□Urgent □Return receip	t □Expand Group □Restricted □Prevent Copy	
From:		
Sent:	2025-08-27 星期三 09:09:41	Submission Number:
To:	tpbpd/PLAND <tpbpd@pland.gov.hk></tpbpd@pland.gov.hk>	TPB/R/S/H5/32 -S029
Cc:		1 0/11/0/11/0/2
Subject:	DRAFT WAN CHAI OZP - S/H5/32 - OBJECT	TION

Dear TOWN PLANNING BOARD Chairman and Members Re: DRAFT AMENDMENTS WAN CHAI OUTLINE ZONING PLAN S/H5/32

Photo 2. Only Vehicular access up steep narrow and dangerous St. Francis Street.

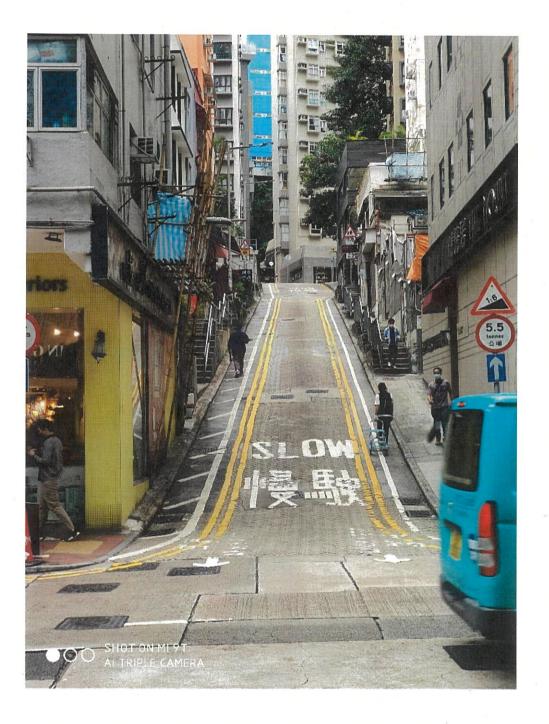
Heavy goods vehicles are banned from St. Francis' Street on safety grounds (see photo 2 attached below)

Photo 3. St. Francis' Junior School Students leaving down St.Francis Street.

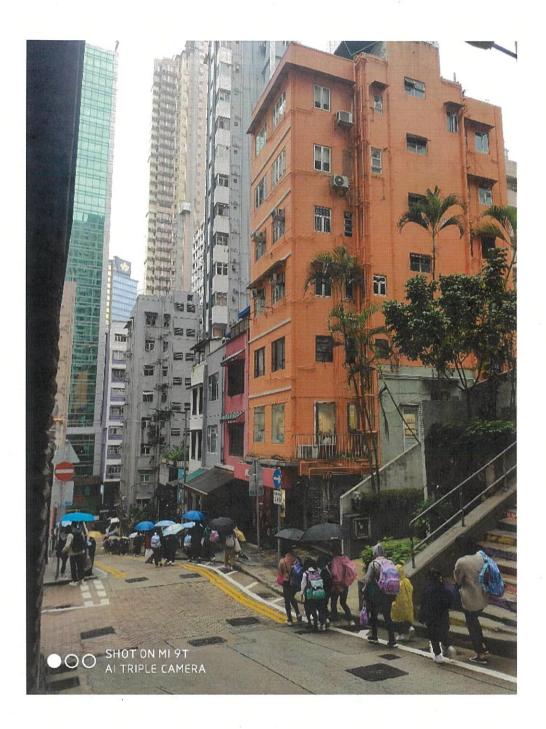
Junior school pupils are arriving or departing. There are **NO designated parking/loading/unloading bays** so that cars and delivery trucks stop in lane in St.Francis Street or drive into the St.Francis Yard cul-de-sac. (**see Photo 3** attached below)

and security of our students is our gravest concern" she could have had in mind the ability of the tower's residents to peer into the classrooms of her girl students, and about the traffic impact and risk to her junior students at steep and narrow St.Francis Street (see photo 3 attached below)
